Docket Items # 8 & 9 BAR CASE # 2015-0289/0290

BAR Meeting October 7, 2015

**ISSUE:** Re-approval of Permit to Demolish/Capsulate and Additions/Alterations

**LOCATION:** 700 South Pitt Street

PROPOSED SITE PLAN 1" = 10'-0"

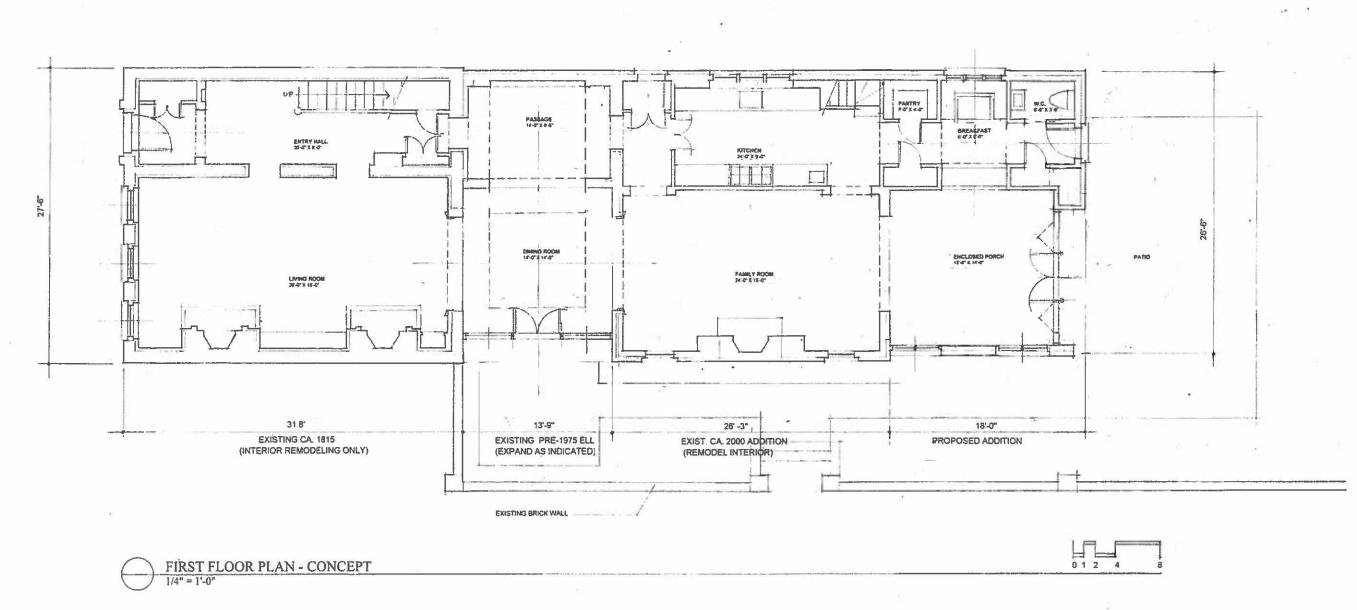
The applicant proposes to **modify** the originally proposed rear addition to the south elevation of the 2001 one-and-a-half story addition. While the footprint of the rear addition will stay roughly the same, the addition will now be a full two stories in height. The west elevation of the new addition will have single, multi-light doors on the first floor and two casement windows on the second floor. The south elevation will have a triple casement window in the gable end, while the first floor will have a pair of double French doors flanked by single multi-light doors. A modest overhang with a standing seam roof will project beyond the rear elevation over the patio doors. On the east elevation of the new addition, which will not be visible from a public right-of-way, a number of casement windows will be added. The roof material on the addition will be architectural grade composition shingles to match the existing rear addition.
